**Total Maximum Daily Loads (TMDLs)
for
Dissolved Oxygen and Iron
in the Waters of
Duck Creek in Mendenhall Valley, Alaska**

October 2001

Appendix F: Response to Public Comments

Figure 8. Validation of simplified model simulation of iron and DO for June 1997

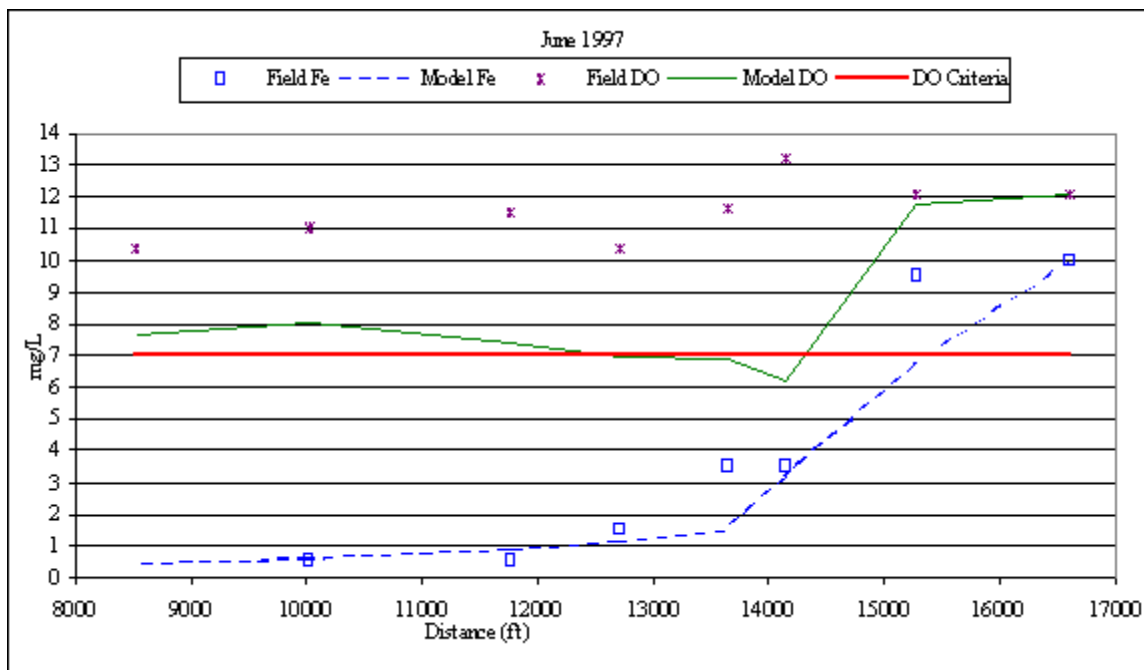
<p>9. Page 20, last sentence of first (incomplete) paragraph: “The predicted values are deemed to be sufficiently accurate given the limited amount of iron data available...” According to figure 8 the predicted values for DO are uniformly lower than the observed data in most cases by large amounts. In particular the model predicts DO levels less than the 7 mg/L minimum allowable, while the observed levels exceed this level by about 50%.</p>	<p>A section entitled “Limitations of the Iron and Dissolved Oxygen Model” has been added to the TMDL and describes the model in more detail. The available data allowed only a very simplified modeling approach. The observed DO values in figure 8 represent supersaturated conditions. In order to simulate supersaturation, the model would have had to include a simulation of algae. Sufficient data were not available to support such a detailed modeling approach. As a result, the model could not simulate the supersaturated DO values seen in Figure 8. However, the model simulates iron and non-supersaturated DO observations well, as seen in Figures D-1 and D-2.</p>

Figure D-1. Calibration of simplified model simulation of iron and DO for August 1995

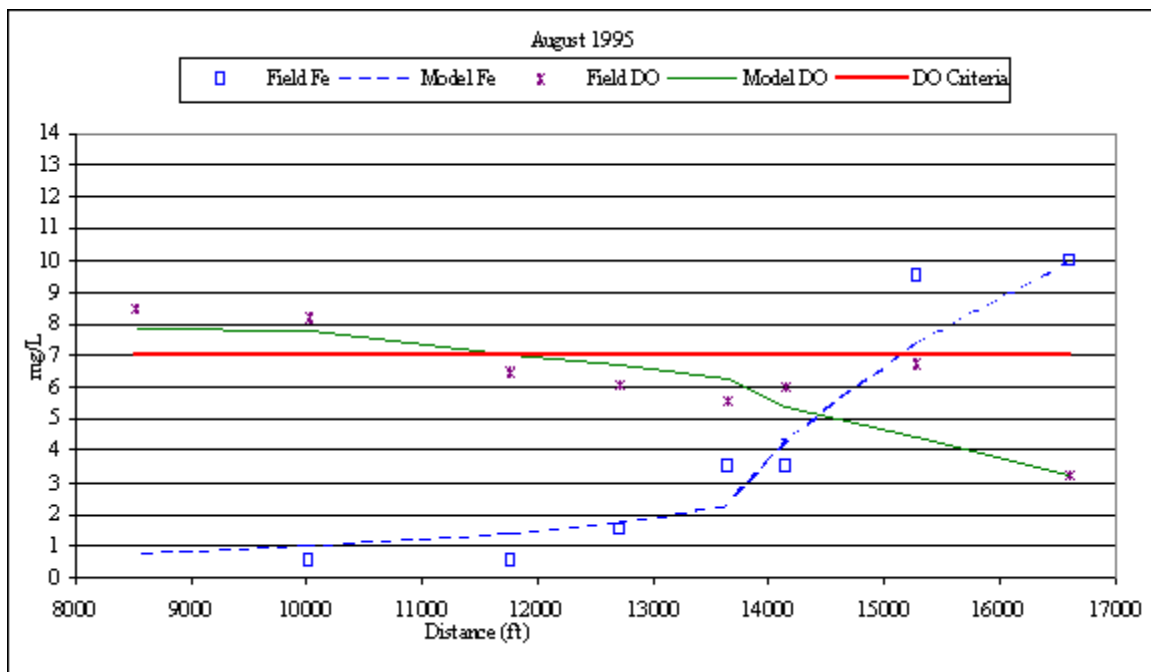
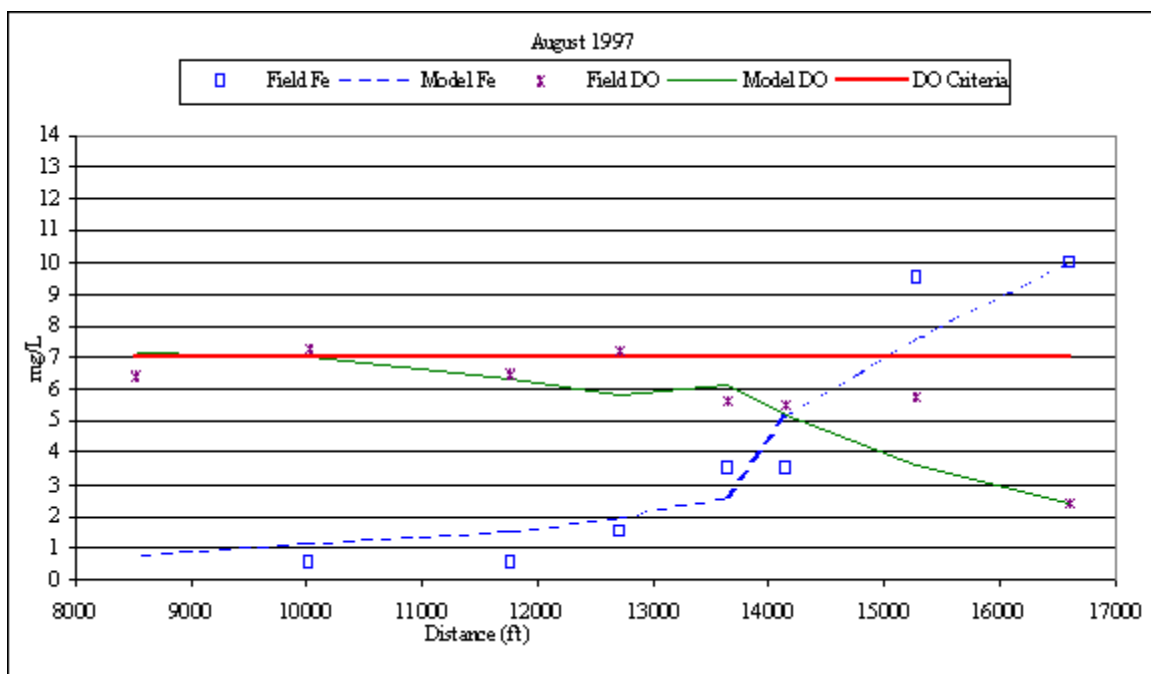
Comment	Response
<p>11. Page 22, second paragraph: “The accuracy of this simplified model analysis is estimated at 0.1 mg/L.” None of the charts comparing the model’s output to actual measured conditions come close to having this degree of accuracy. The model is off by several mg/L in figure 8, approximately 1 mg/L in Figure D-2 and even in the calibration trial Figure D-1, the predictions are more than 0.1 mg/L from the field measurement at half of the stations. If the model actually did predict DO to within 0.1 mg/L it would be a useful tool indeed, but if Figure D-2 (or Figure 8) is representative, it’s usefulness at this time is questionable.</p>	<p>A section entitled “Limitations of the Iron and Dissolved Oxygen Model” has been added to the TMDL and describes the model in more detail. The assumption of iron following an exponential decay creates an error in the DO that can not be precisely quantified. The accuracy of the model equations is estimated at 0.1 mg/L. However, uncertainty associated with reaction rates and other variables means that the error is likely larger. The model is believed to simulate the system as accurately as possible with the available information. The use of first order reaction rates represents a conservative assumption that accounts for some of the model error. First order rates could overestimate the uptake of iron and overpredict the oxygen demand.</p>
